**RE: Eagle Ranch MVD-Retail (Phase 1: MVD Building)
9651 Eagle Ranch Rd NW (Tract C, Cottonwood Pointe)
Request for Certificate of Occupancy – 30 Day Temporary
Hydrology Final Inspection - Approved
Engineer's Stamp Date 8/22/17 (B13D002C)
Certification Dated: 3/1/18**

**RE: Eagle Ranch MVD-Retail (Phase 1: MVD Building)
Eagle Ranch Rd (Tract C, Cottonwood Pointe)
Request for Certificate of Occupancy – Permanent
Hydrology Final Inspection - Disapproved
Engineer's Stamp Date 8/22/17 (B13D002C)
Certification Dated: 3/1/18**

EAGLE RANCH NM MVD - RETAIL
Albuquerque, New Mexico
GRADING & DRAINAGE PLAN
Overall Site & Drainage Basins

G
C-3.0

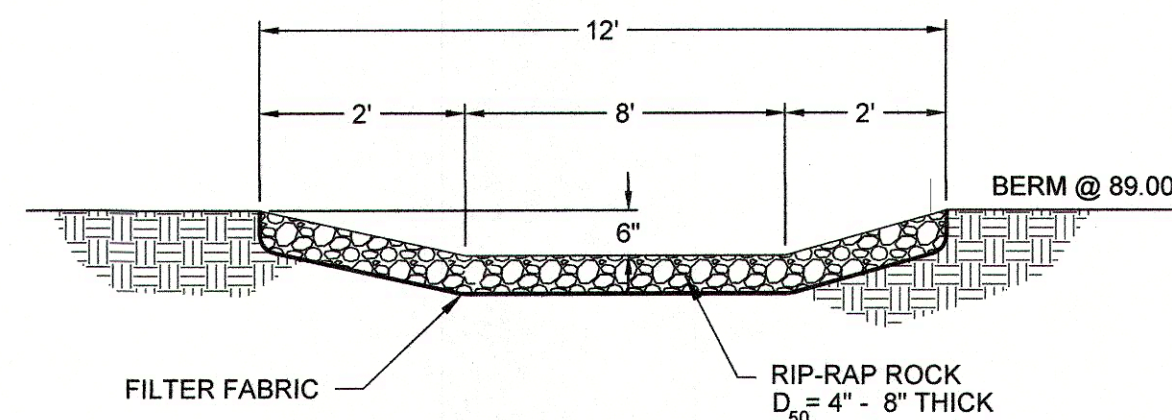
1. First Flush Pond "B" needs to be deepened to 12" below top of grate in order to
provide first flush ponding, per detail G, C-3.0:

1. First Flush Pond "B" needs to be deepened to 12" below top of grate in order to provide first flush ponding, per detail G, C-3.0:

H
C-3.0

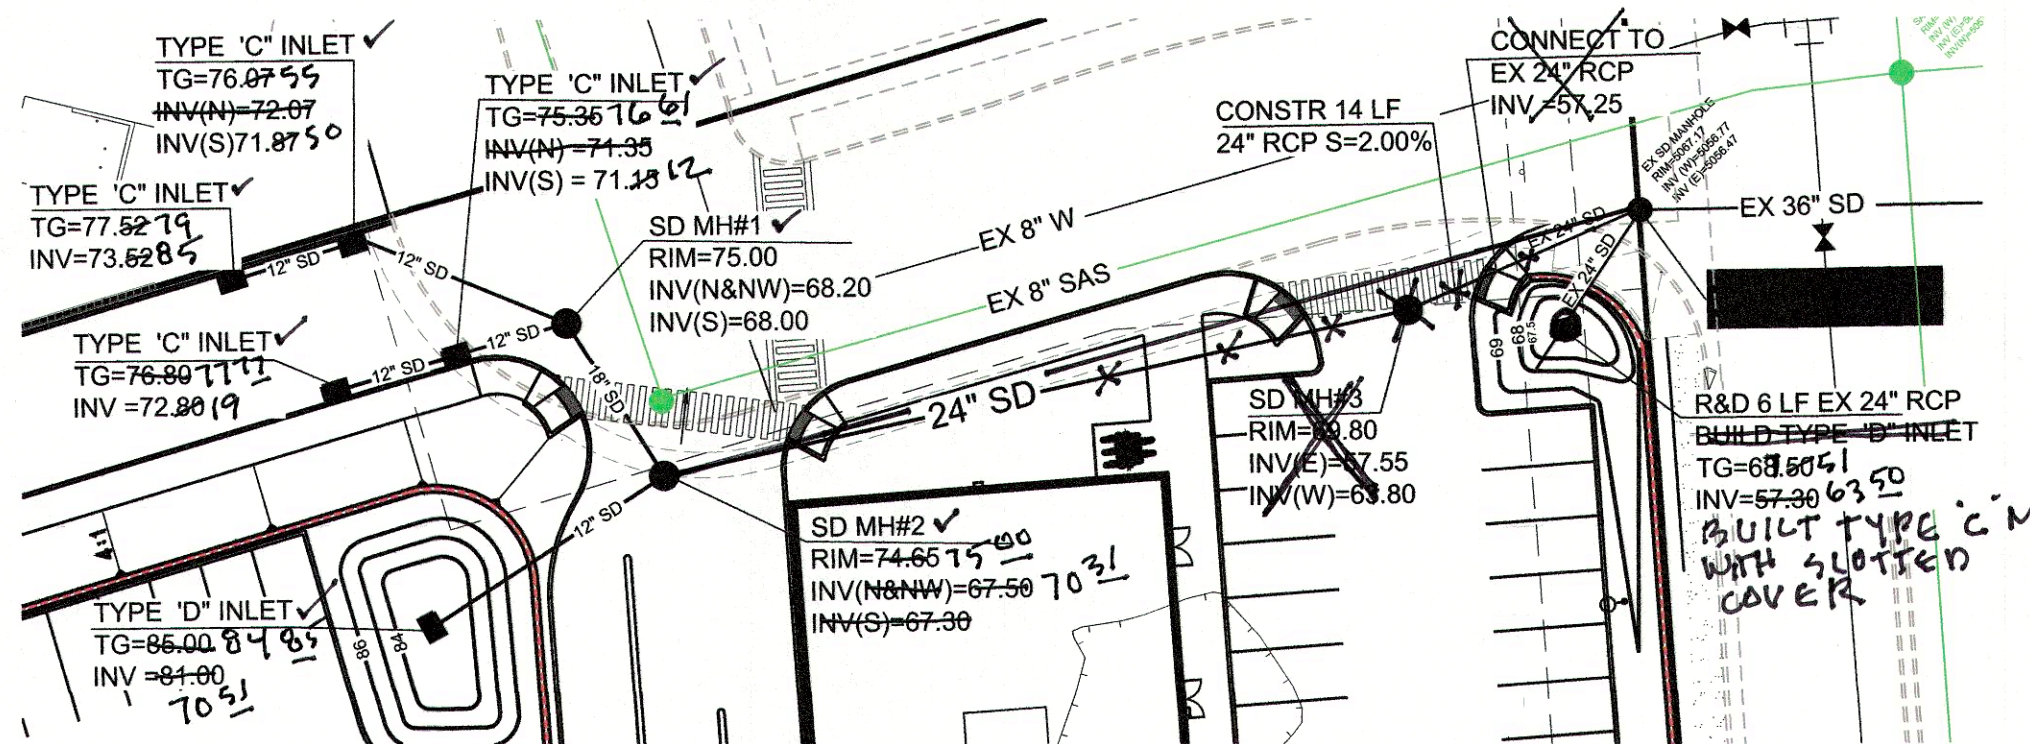
2. The rock for the emergency spillway needs to be replaced with d50=4" rock, per detail H, C-3.0:

2. The rock for the emergency spillway needs to be replaced with d50=4" rock, per detail H, C-3.0:
